Detailed Site Plan

DSP-13008

SUBJECT: Detailed Site Plan DSP-13008
Type 2 Tree Conservation Plan TCP2-018-13
Gilpin Property

GILPIN PROPERTY

RENDERED LANDSCAPE PLAN

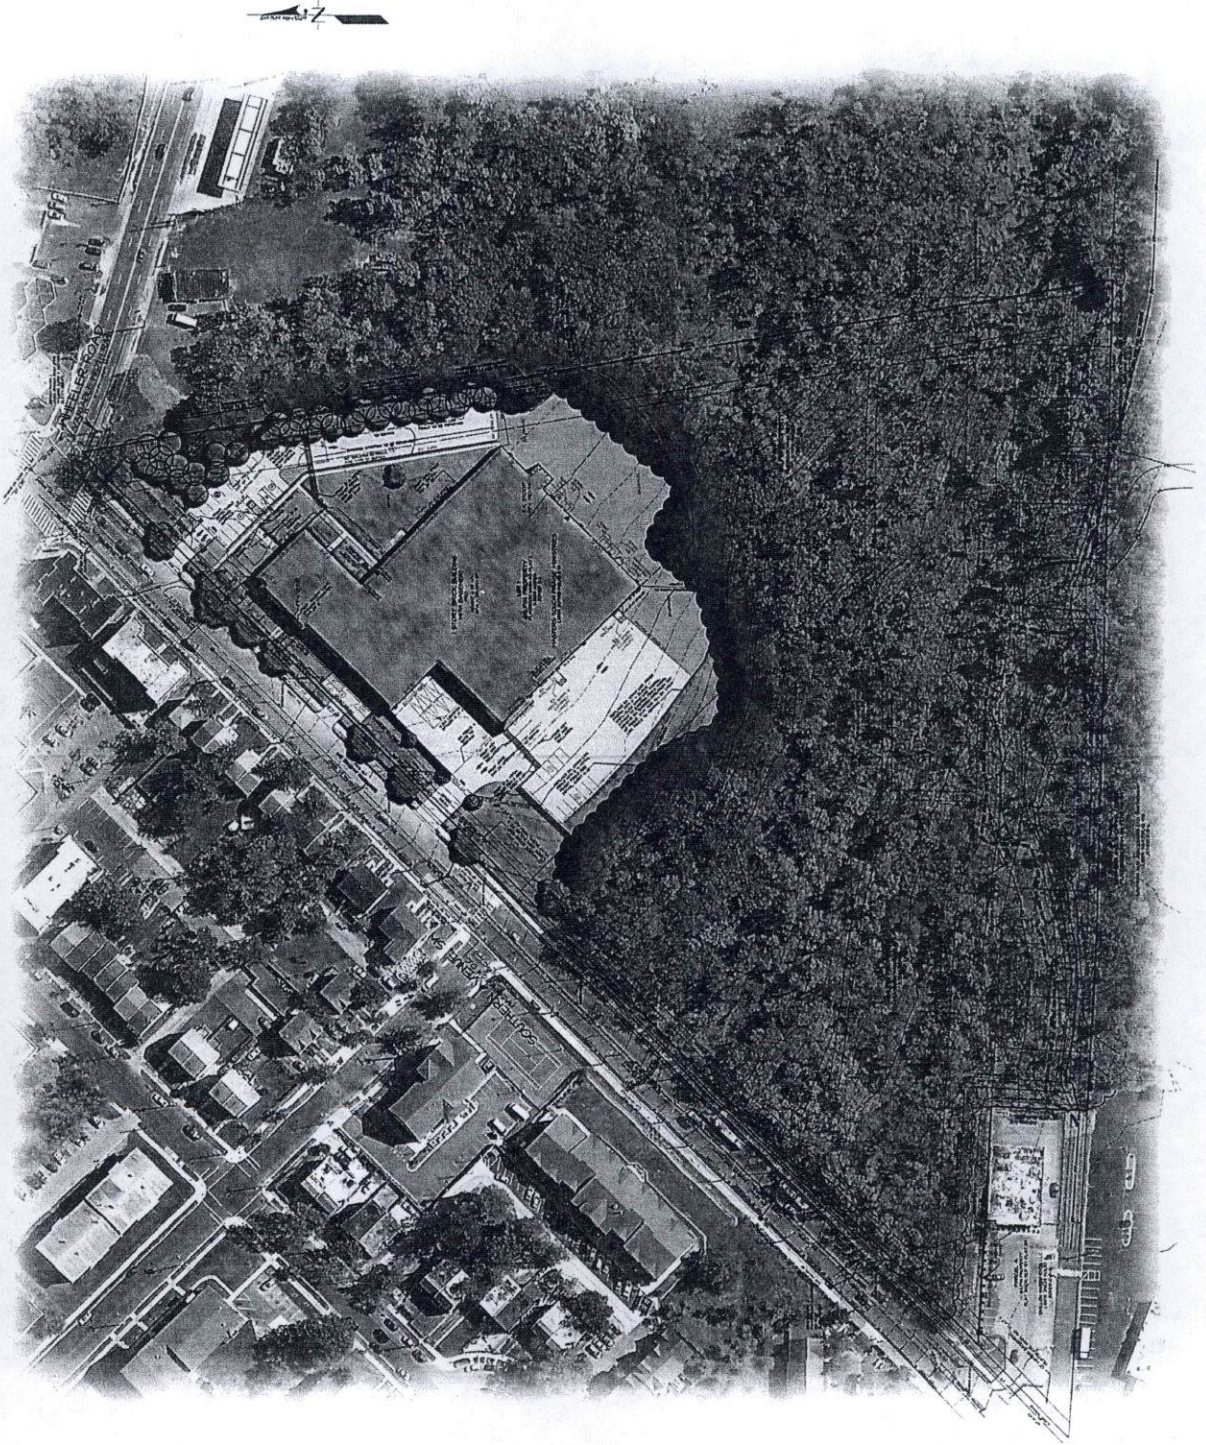
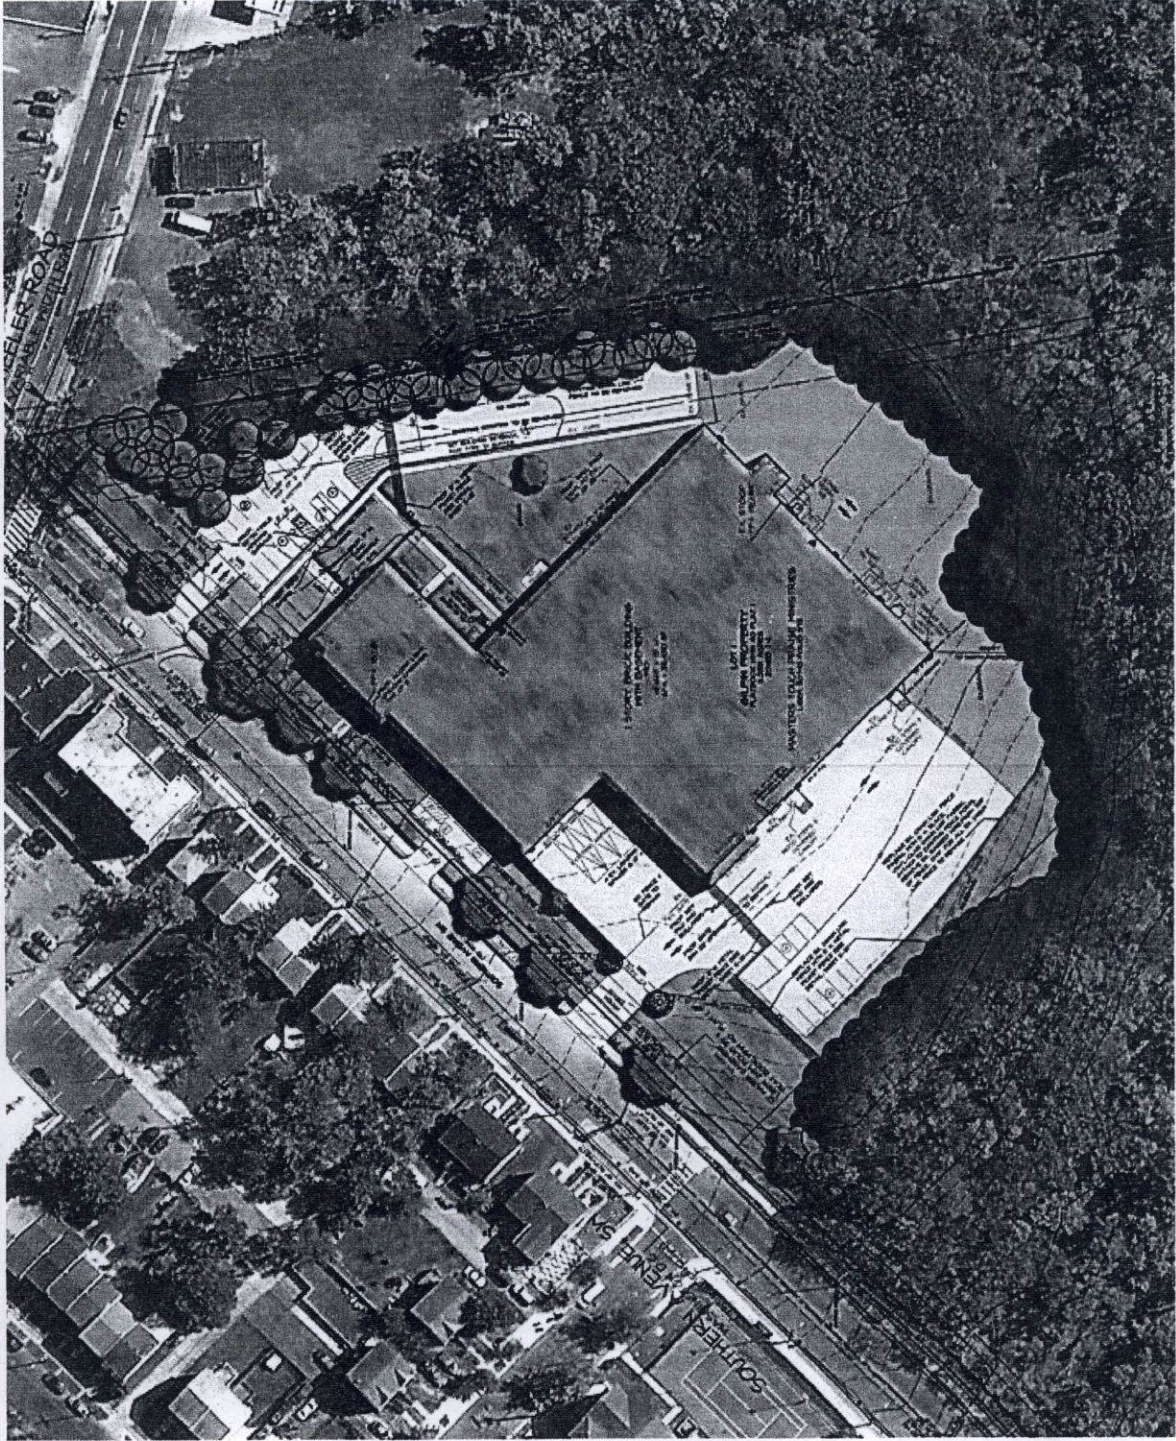
Once the parking lot is removed, two additional street trees should be provided as a continuation of the Southern Avenue streetscape. These plantings are subject to modification by the District of Columbia.

no structure; therefore, a 50 percent reduction is permitted. The applicant proposes to remove an area of existing parking and plant 31 shade trees along this property line, which will meet this requirement.

- e. A note shall be provided stating that "blacked-out windows along Southern Avenue shall not be permitted."
 - f. The three-space parking lot along Southern Avenue shall be removed and replaced with green area. Two additional street trees shall be provided near the removed driveway as a continuation of the streetscape, subject to modification by the District of Columbia.

ARCHITECTURAL ELEVATIONS

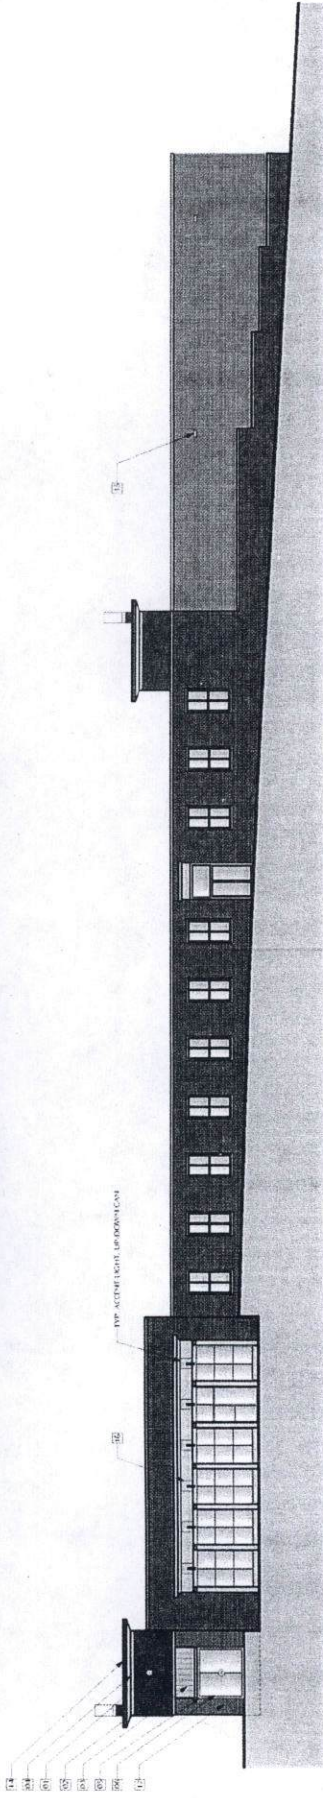
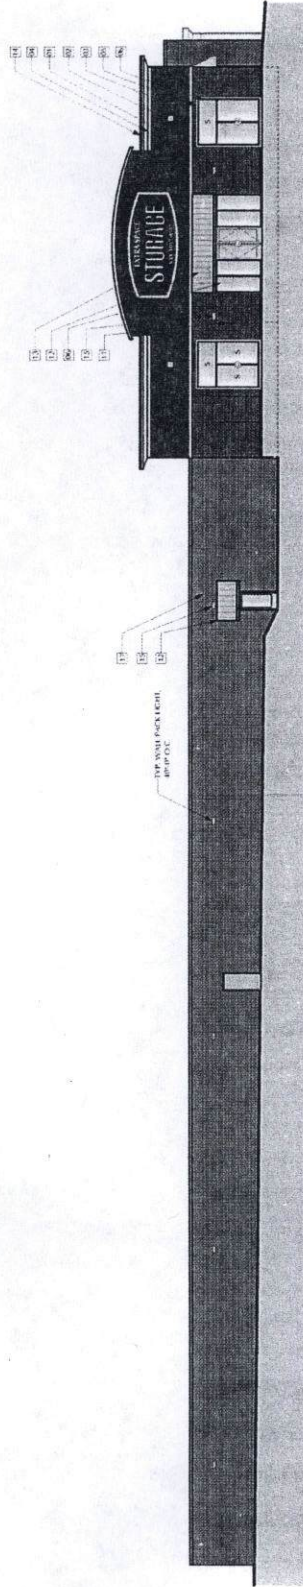
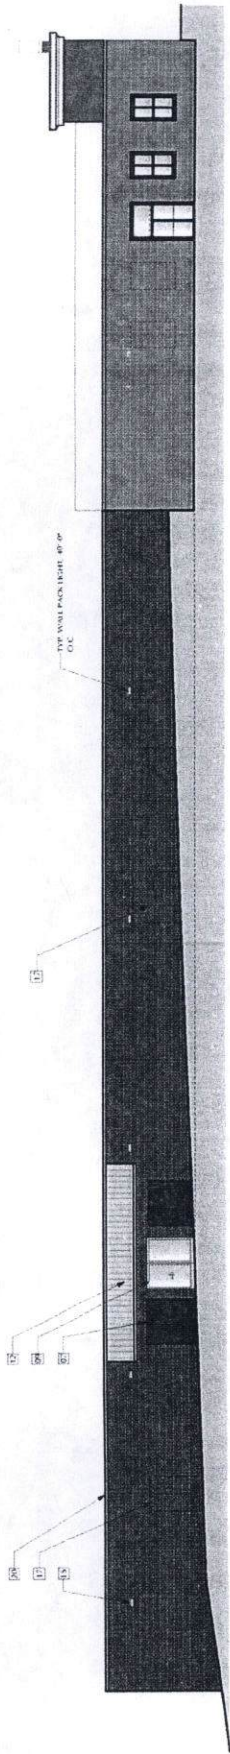
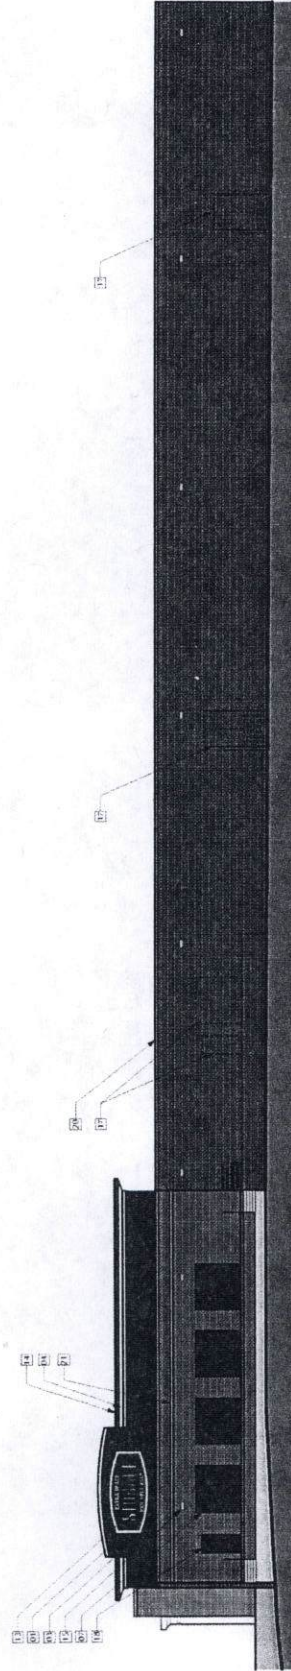
The primary building entrance for the self-storage business will be along the northeastern building elevation. In this area the building will be modified to provide glass doors and windows with tan, metal awnings above. A parapet wall is proposed along this elevation to increase the height of the building in the area of this primary entrance. A 10-17-foot-tall-parapet wall above the existing roof is proposed. This wall will be clad with green exterior insulation finishing system (EIFS) with a white cornice treatment. A secondary building-mounted sign is proposed along the southwest building elevation where a band of green EIFS and white cap flashing is proposed along the top of the existing building.

Other building modifications include removing stairs, existing doors and windows, and in some locations adding doors. The proposed brick used to infill the existing window and door openings should match the existing brick building. Notes to this effect should be placed on the architectural elevations. The service doors and loading doors are proposed to be painted green to match the signage. This could draw attention to the loading area from the right-of-way. These doors should be painted in a more neutral color compatible with the brick building. The front building elevation facing Southern Avenue will remain largely unaltered with the exception of the northeast corner of this elevation where a metal awning is proposed and a portion of the green EIFS parapet feature is continued.

Comment: The architectural elevations indicate that no entrances to individual units are visible from any street or from adjoining land in any residential or commercial zone.

Comment: The existing building has a height of 15 feet. The maximum height of the building with the parapet features is approximately 32 feet and complies with this requirement.

1. Prior to certificate of approval of the detailed site plan (DSP), the following revisions shall be made, or information shall be provided:
 - a. A note shall be provided to indicate that the brick proposed to infill the existing windows and doors shall match the existing brick building.

- b. The service and loading doors shall be painted in a neutral color compatible with the brick building.
 - c. The location and square footage of the office shall be indicated on the detailed site plan.

- d. The interior layout of the storage units shall be modified so a hallway or corridor is provided along the interior of the Southern Avenue elevation, allowing transparent windows.
